## Shoalhaven Traffic Committee

**Meeting Date:** Tuesday, 14 March, 2023

### Agenda

**Proposed Bridge Load Limits  
Swan Lake Bridge  
The Springs Road  
Sussex Inlet / Cudmirrah**

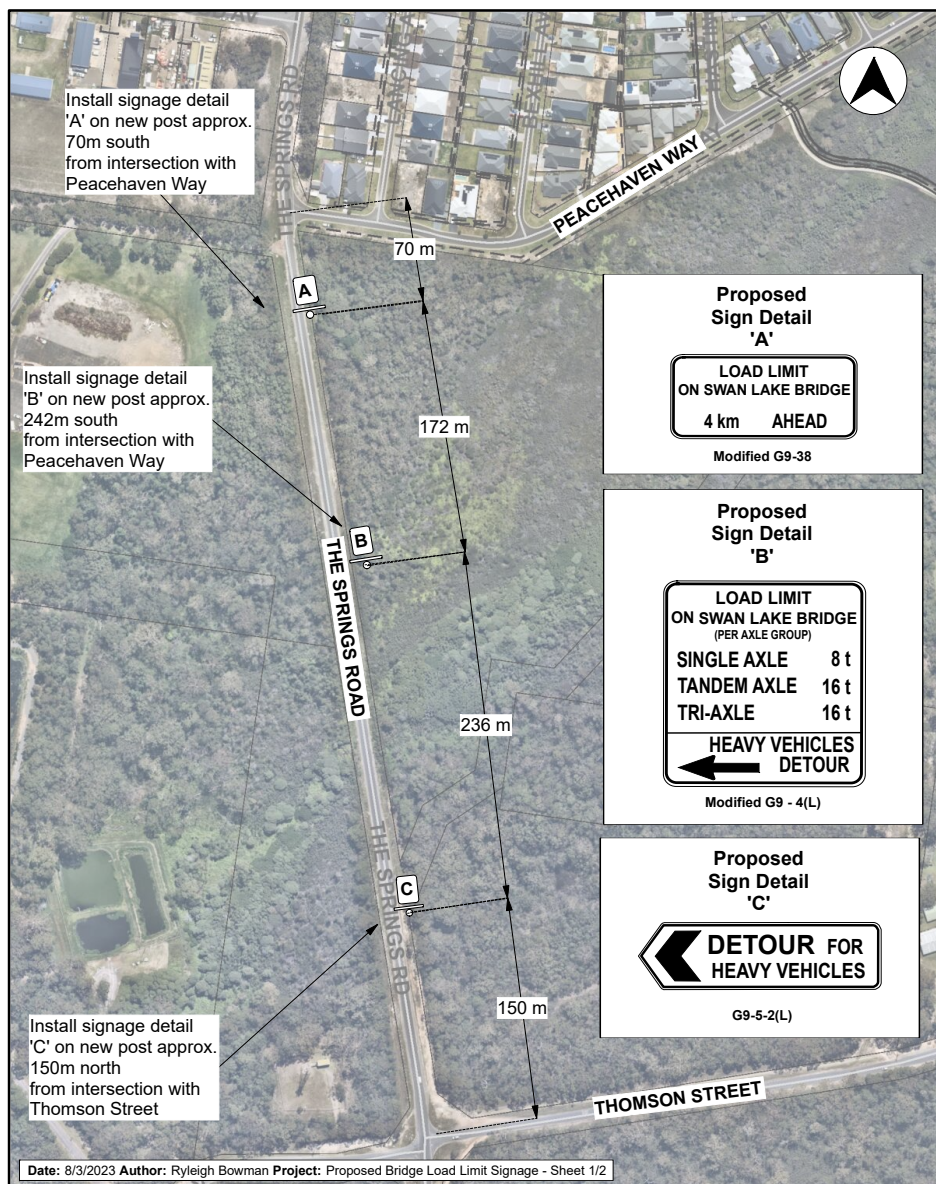
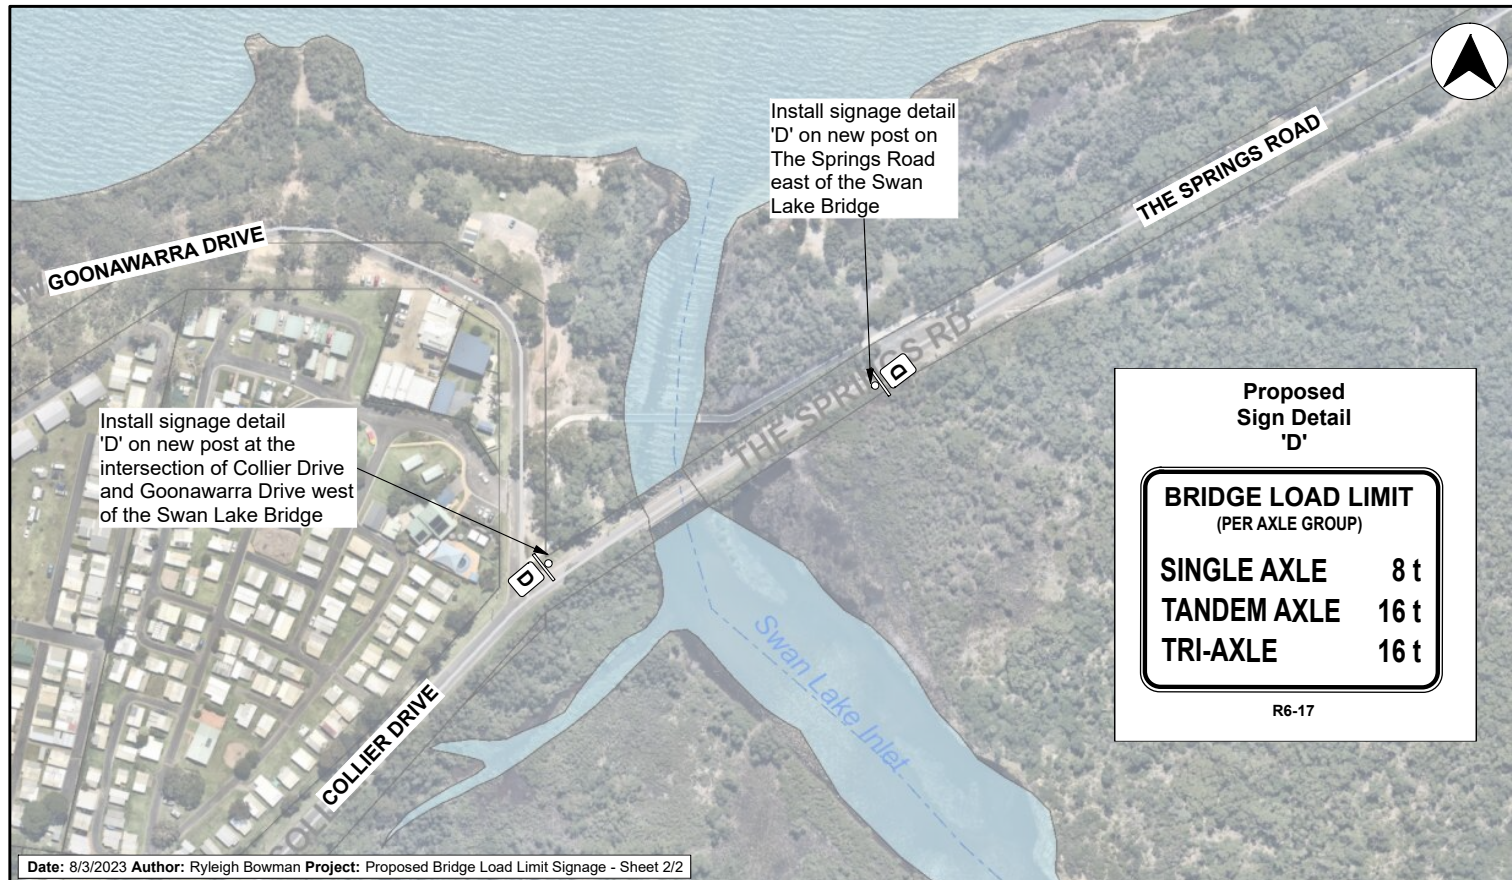
- A modified G9-38 sign “Load Limit on Swan Lake Beach – 4km Ahead”,
- A modified G9-4(L) sign indicating the load limits per axel group and the upcoming detour via Thomson Street, and
- A G9-5-2(L) sign at the intersection of the Springs Road and Thomson Street.

At the Swan Lake Bridge, it is proposed to install R6-17 signs on both approaches, in accordance with AS1742.2 - s4.5.6.1(d).

That the Chief Executive Officer (Director City Services) be advised that the Shoalhaven Traffic Committee accept this report for information only and have no objection to the proposed load limit signage for the Swan Lake Bridge along the Springs Road, Cudmirrah (per Plan No: D23/86807).
